**CERTIFICATE OF APPROPRIATENESS**

**Property:** 1917 Crockett St, Lot 1, Block 314, Shearn Addition Subdivision. The property is a vacant 2,315 square foot (47' x 49'-3") corner lot.

**Proposal:** New Construction – Residence

Construct an approximately 2,260 square foot, two story residence on a corner lot.

**BLOCKFACE RENDERING – FRONT FACING CROCKETT STREET**

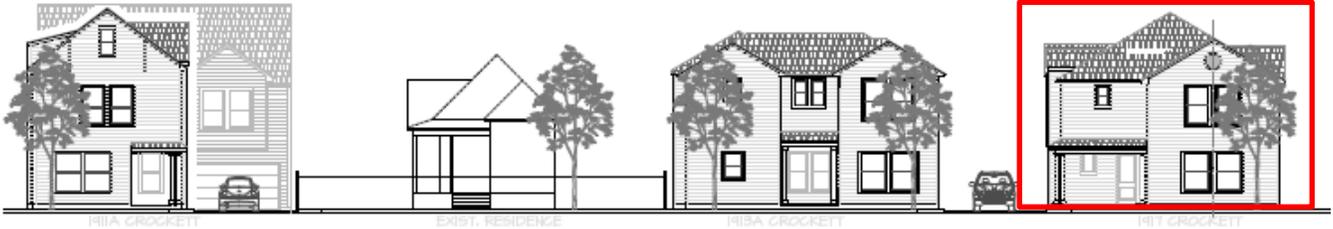
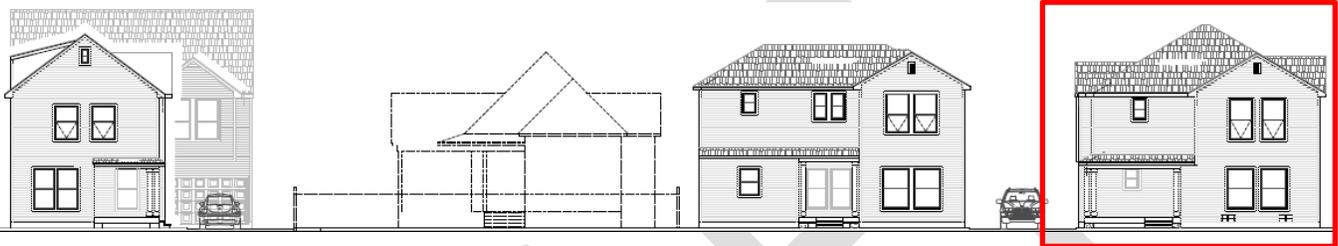
*There is one contributing structure on this blockface that has a setback of 11'. The contributing structure on White Street has an approximate setback of 5'. The current proposal has a setback of 11' on Crockett and 5' on White Street. The setback on the south side facing the contributing structure on White Street is 3'.*
- (2) The exterior features of the new construction must be compatible with the exterior features of existing contributing structures in the context area;

**NORTH ELEVATION – FACING CROCKETT STREET**

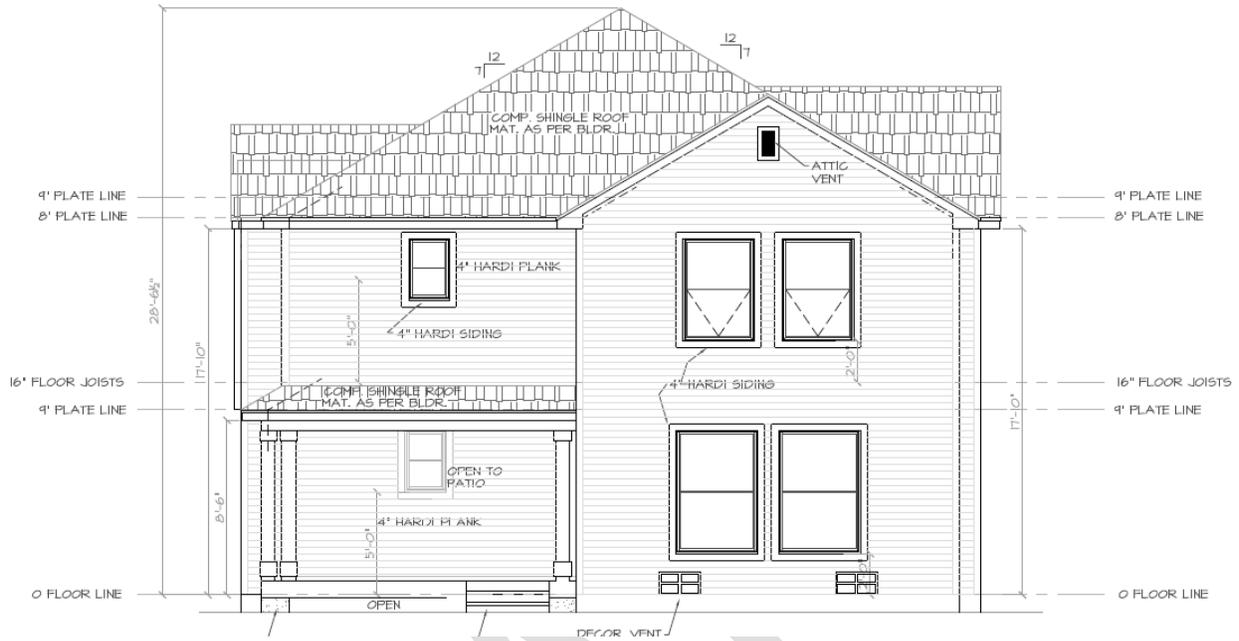
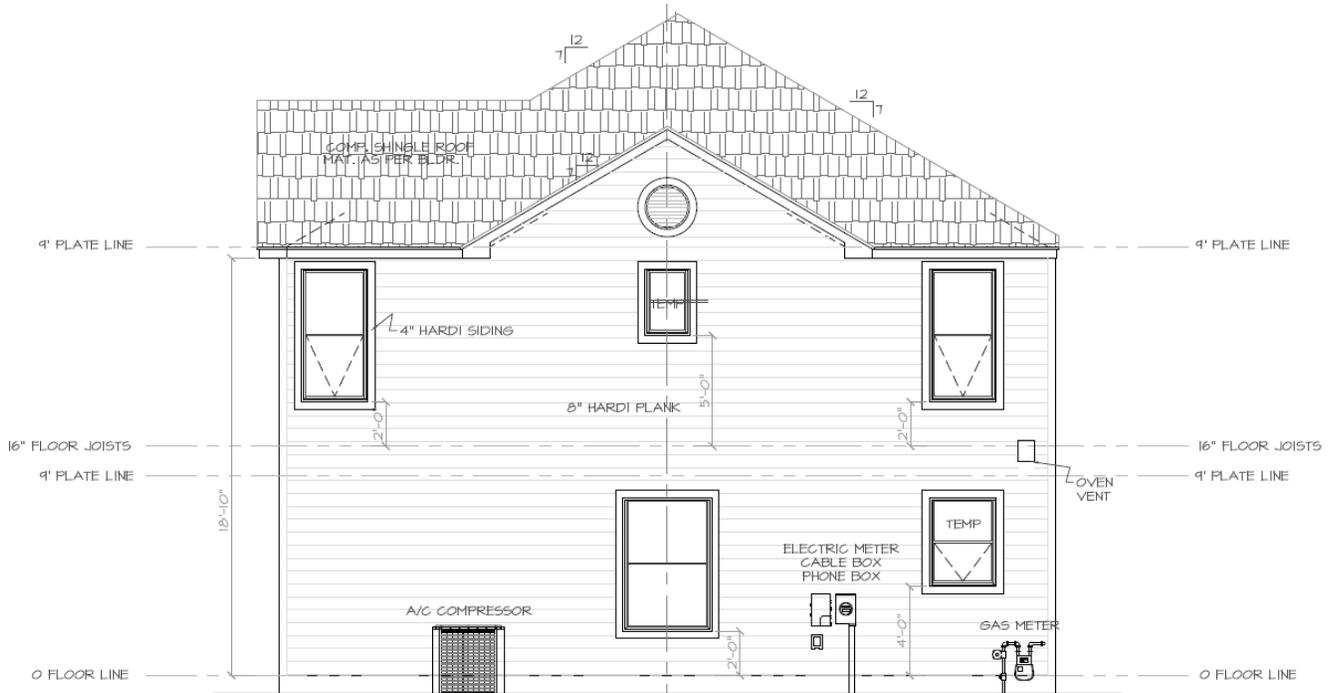
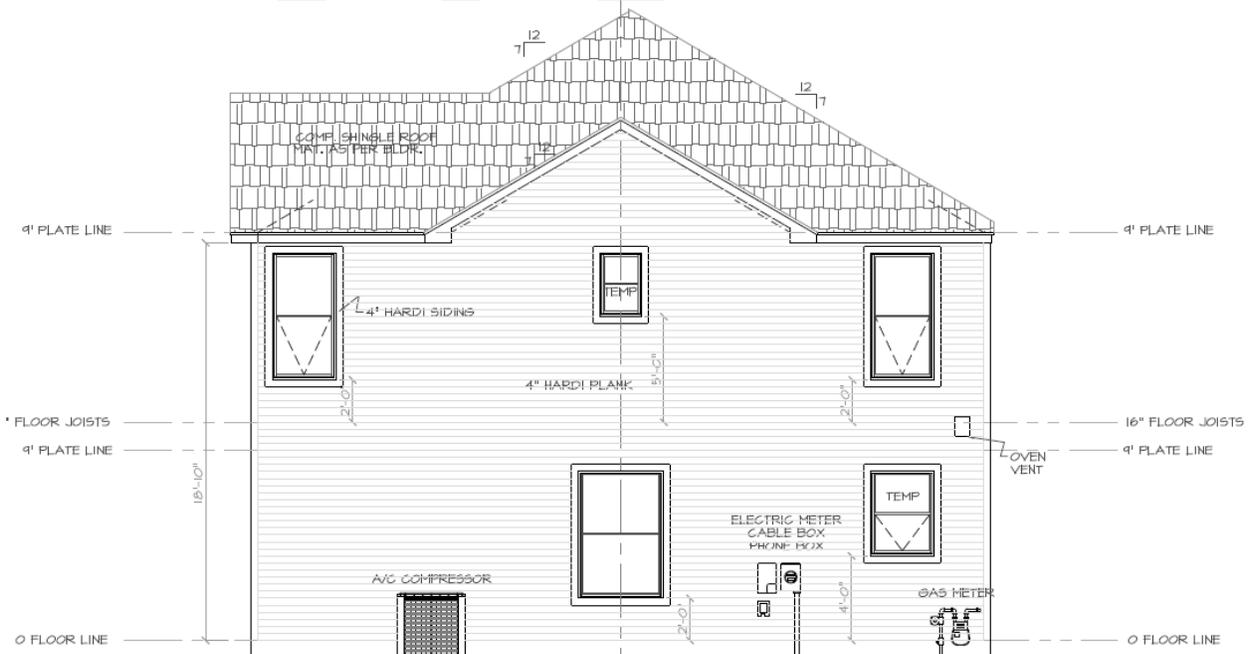
*The front porch is only 6' deep which is a typical depth and more fenestration was added to the elevations facing White Street.*
- (3) The scale and proportions of the new construction, including the relationship of the width and roofline, overall height, eave height, foundation height, porch height, roof shape, and roof pitch, and other dimensions to each other, must be compatible with the typical scale and proportions of existing contributing structures in the context area unless special circumstances, such as an atypical use, location, or lot size, warrant an atypical scale and proportions;
